**Job No:** 2023-4934  
**File Ref:** N01-SG-Response to Highways (231130)  
**Date:** 30<sup>th</sup> November 2023  
**Job Title:** Land to the rear of 726 Field End Road, Ruislip

**Subject:** Response to Highways Request for Information  
 Planning reference 77818/APP/2023/300

Drawing  
Proposed  
Site Plan

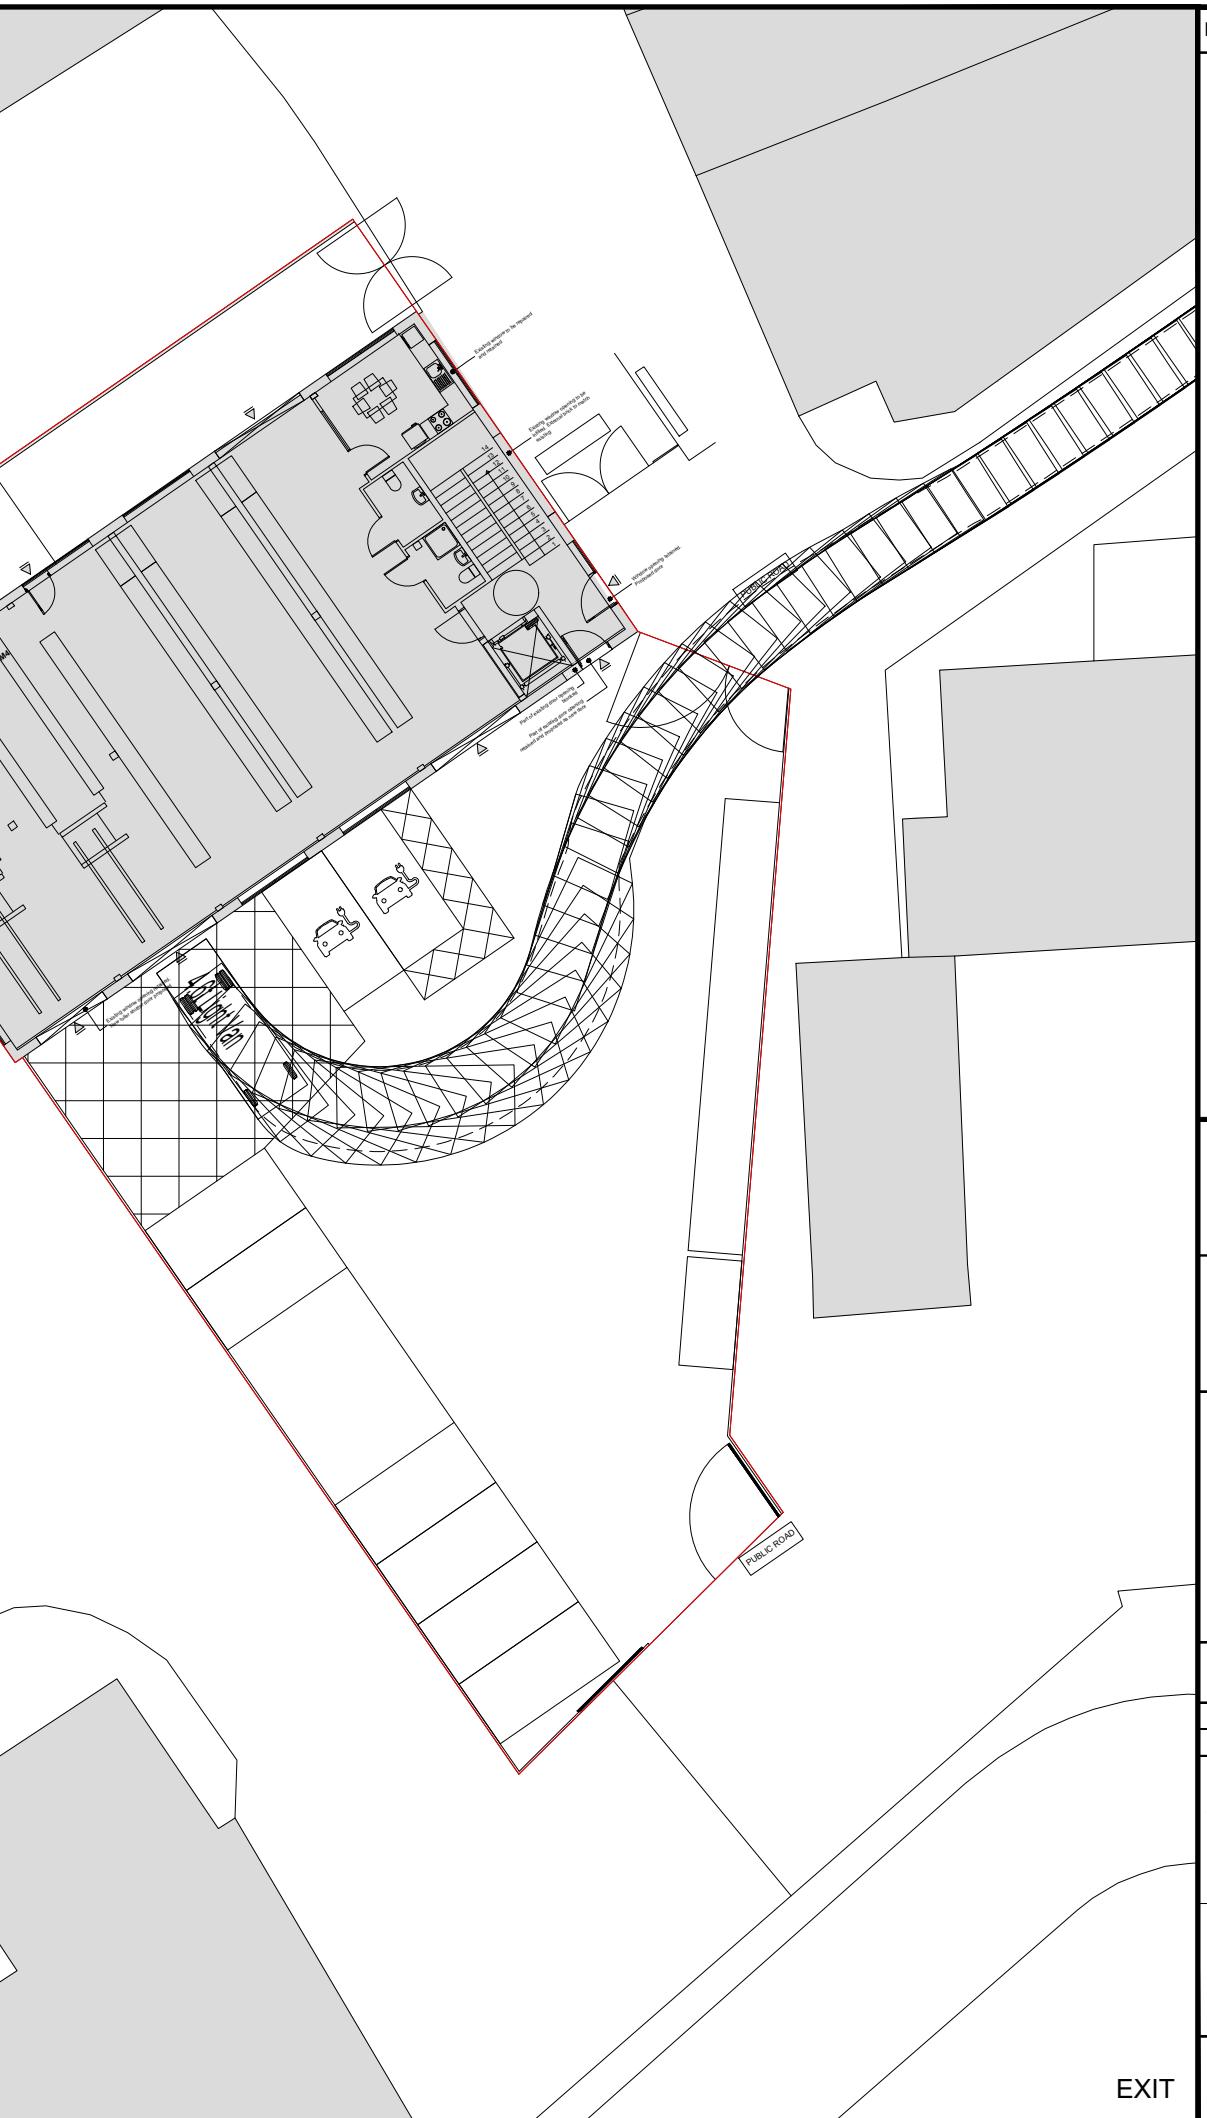
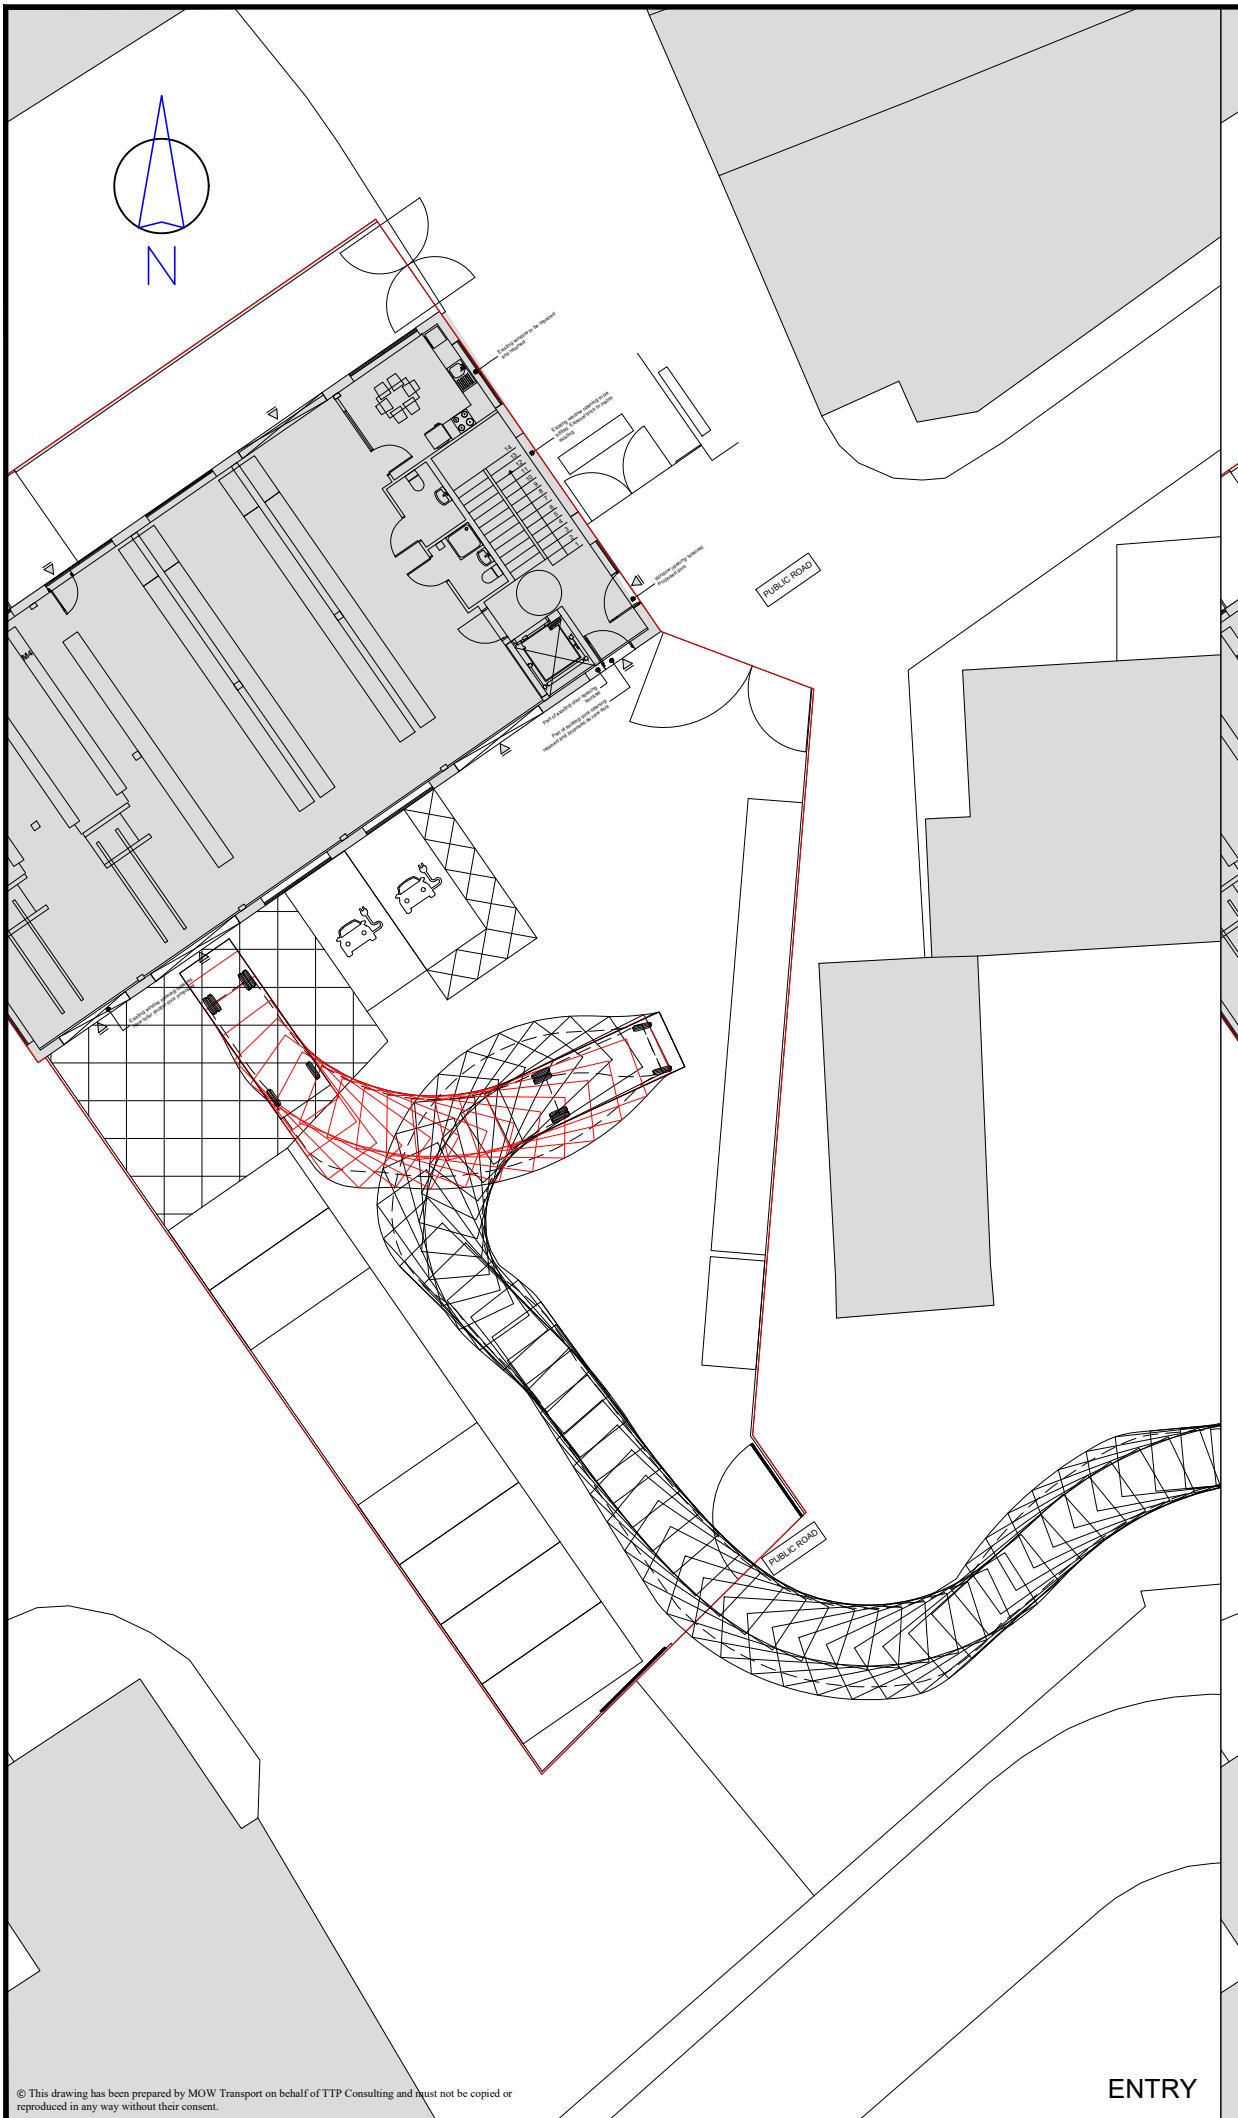
Several formally marked on-plot parking spaces are currently present but, it would appear that these would be deleted to facilitate the factory operation technically rendering the proposal as 'car-free'.

The maximum local parking standard for an E(g)(iii) use class would require in the region of up to 10 spaces and none are to be provided. 4 formal spaces are currently provided on-site which would be lost due to the reconfiguration of the envelope. This action could potentially encourage some undue parking displacement onto the unrestricted roadways in proximity of the address such as 'Brackenhill' to the south (designated as social housing land).

13. It is proposed that eight parking spaces will be provided to serve the site at Field End Road. Of these, two will be provided with electric vehicle charging points and one will be accessible.

P01 Parking Spaces added 27.11.23 CS  
Rev Notes Date By
